I MOVE TO authorize the Municipal Administrator to execute a Change Order with CBC Construction, Inc. to install an AYC guardrail along the breakwater spur boardwalk and transfer \$40,000 from the Commercial Passenger Vessel Excise Tax Fund (Fund 194) to the Sea Walk Project (Project No. 90695).

MEMORANDUM

Subject: Sitka Sea Walk Breakwater Spur Boardwalk - Guardrail

BREAKWATER
SPUR

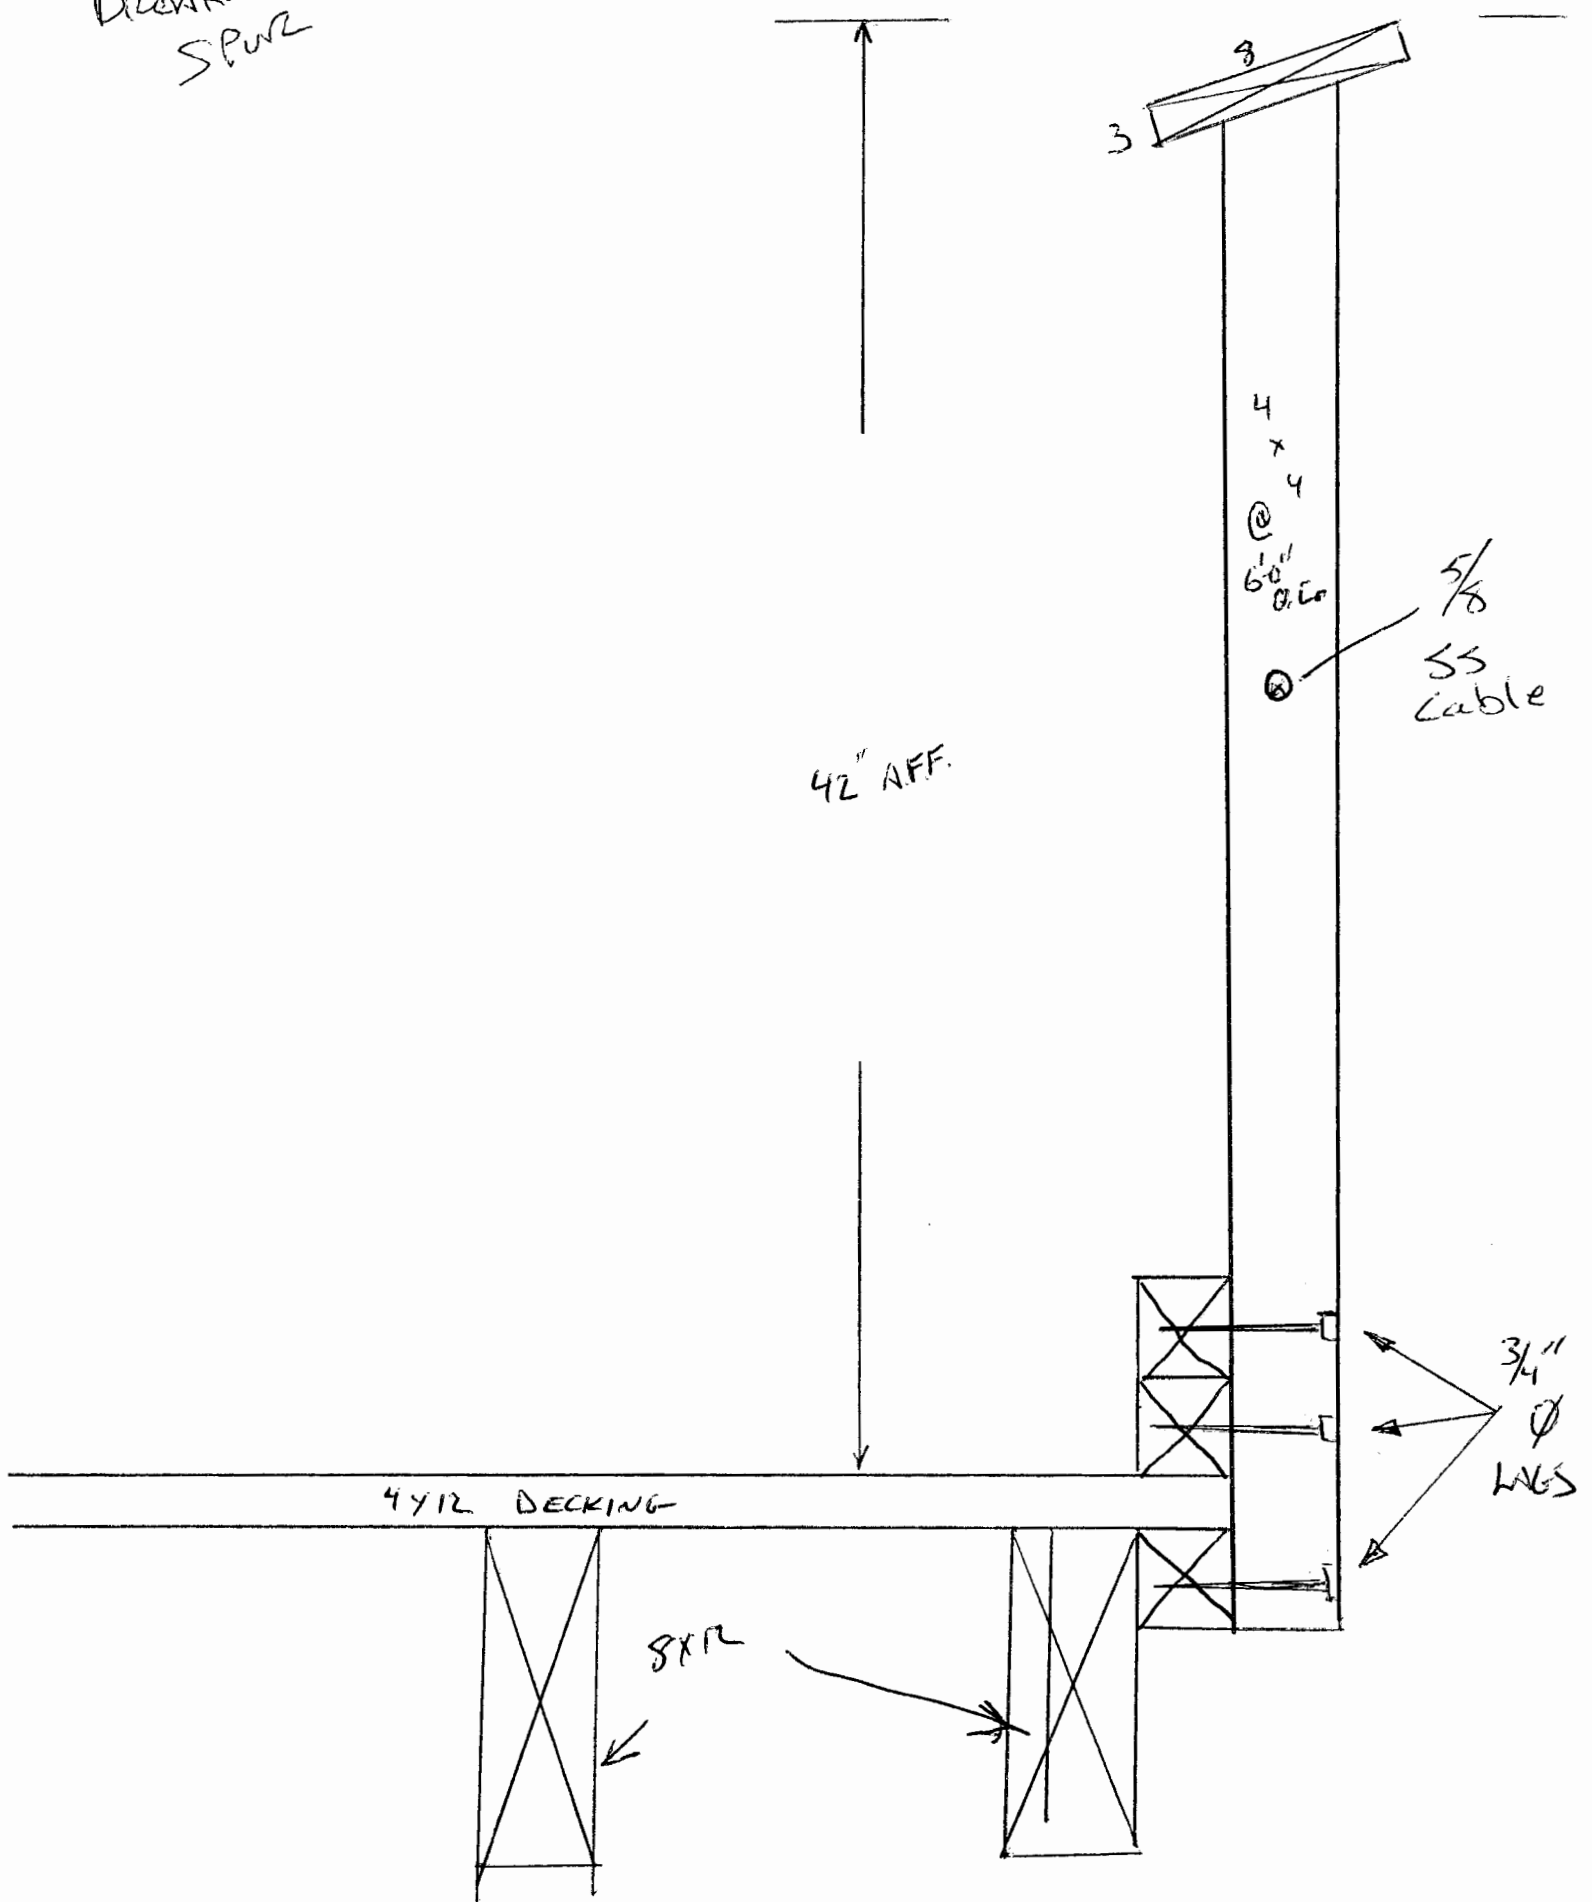
I am in need of the cost to construct an AYC railing along both sides of the breakwater spur boardwalk. The rail must be 42" high (min). Per your sketch provided (see attached) the rail system will consist of 4x4 AYC posts @ ~6'-0" on center, with 3x8 AYC canted top rail (planed and/or sanded smooth) with a single 5/8" stainless steel cable at mid-height. Please provide a lump sum price for the above scope.

Also, there is a kink in the bw spur boardwalk as constructed. Please provide a lump sum price to remove the kink prior to constructing the new rail.

Install a yellow cedar guardrail per sketch.
Straighten out the boardwalk

LUMP SUM PRICE: \$57,390.00-----+tax
